STAFF REPORT: JULY 10, 2024 MEETING
APPLICATION NUMBER: HDC2024-00266
ADDRESS: 1651 EDISON
HISTORIC DISTRICT: BOSTON-EDISON
APPLICANT: MERISA LEWIS
PROPERTY OWNER: MERISA LEWIS
DATE OF PROVISIONALLY COMPLETE APPLICATION: JUNE 18, 2024
DATE OF STAFF SITE VISIT: JUNE 21, 2024

SCOPE: REPLACE WINDOWS, ALTER EXTERIOR (WORK DONE WITHOUT APPROVAL)
7/10 – Revised report in red; in response to recent submittal of additional information by applicant.

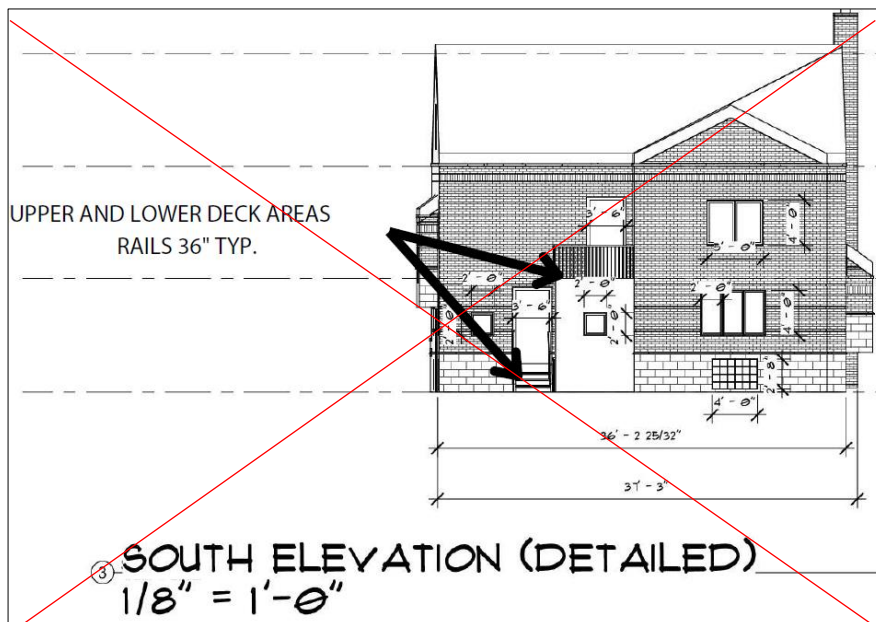
Additional photos submitted by the applicant show there is a crack through the frame directly above the deadbolt, as well as adjacent deeper sections of missing wood, all of which can compromise the strength and security of the door. Therefore, it is staff's opinion this door can be replaced with a new door that matches the horizontal design of the existing historic panel wood door.

Applicant photos.

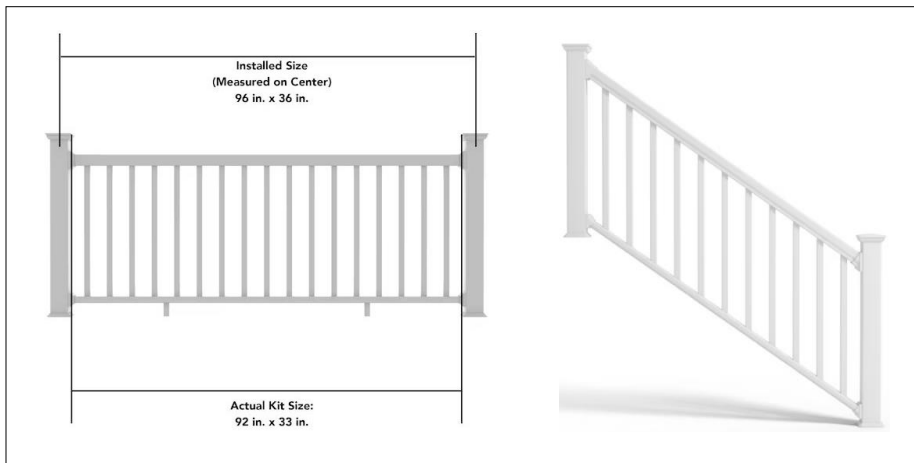
The applicant submitted photos of a different railing design, which includes the defined components discussed above, and is similar to the Google image. However, the railing material appears to be vinyl, rather than wood.

- A wood railing that is compatible with the overall historic character of the building and era of construction, similar to the submitted photos of a vinyl railing, will be selected. A dimensioned drawing of a new railing design that includes specification of wood and painted finish (incl. color) material and finishes, must be

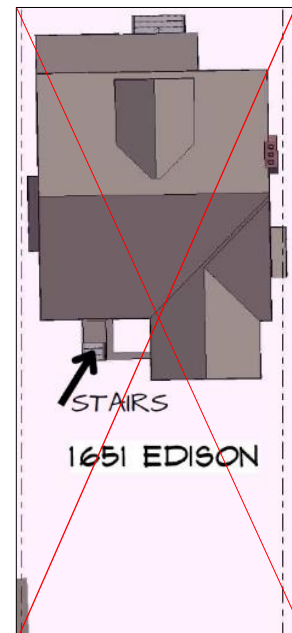
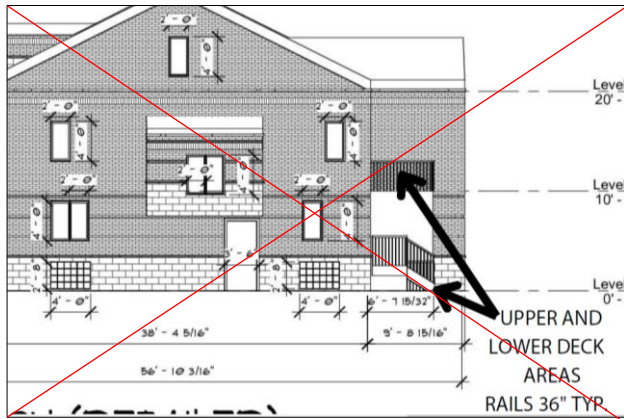
Staff requested additional details for the design and size of the rear entry platform, and that it be dimensioned on a site plan. **The below drawings are what was submitted.**

These revised drawings remain not adequately detailed to confirm the dimensions and design of this construction.

The revised drawing submitted by the applicant on July 9, shows a clear representation of the proposed upper porch and railing, as well as the lower porch platform, railing and stairs. The proposed design does not replicate the original footprint (as shown by the ghost image of the railing and support post). It is staff's opinion, that due to the later partial porch enclosure (which the applicant proposed to retain), the proposed footprint/design is compatible with the current rear wall design and its massing.

North wall

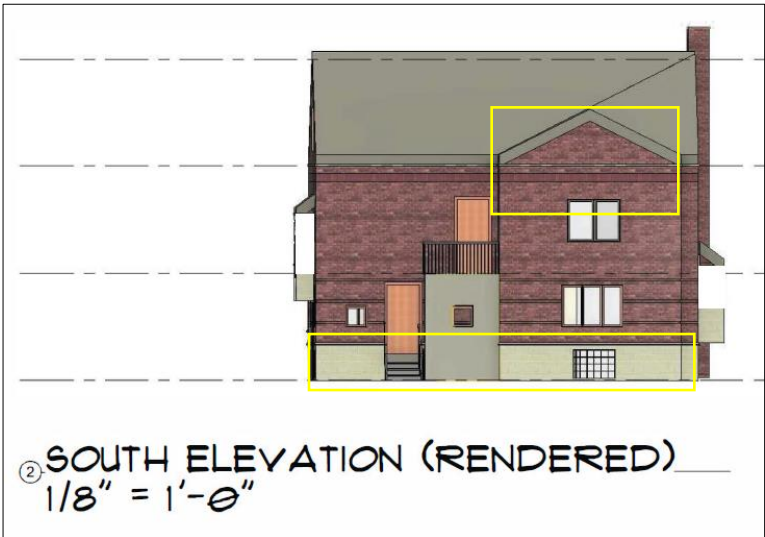
The scale/massing of the house in the rendering makes it appear wider than tall, the dimensions of the dormer are off, and the locations and sizes of the windows openings are not accurate (which includes operation and no muntin/grid patterns shown).

Façade-north Wall

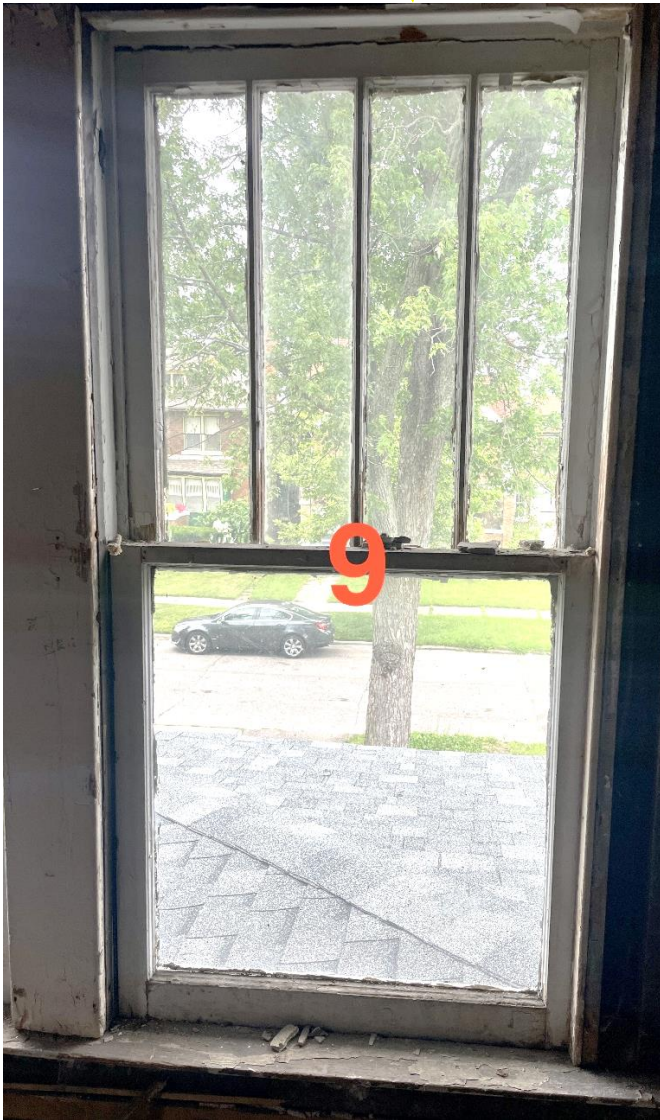
The glass in the bottom sash (6) may need to be replaced and new glass is needed for (7).

Missing lower sash (11, 12); new bottom sashes can be fabricated.

As evidenced in the muntin pattern, the middle window is wider than the flanking windows.

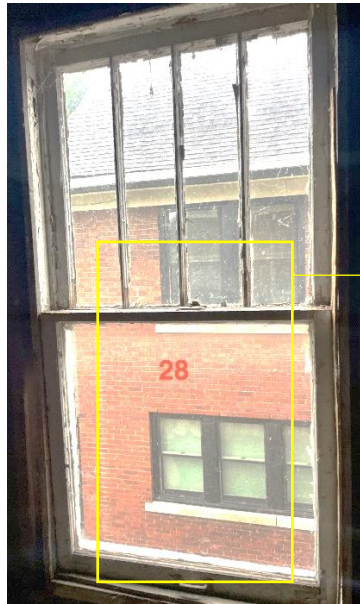
#23 is a non-historic window in a non-historic wall.

#28 is numbered wrong, as all the windows in the rear extension have one-over-one windows, and it appears this window looks towards 1659 Edison (to the west).
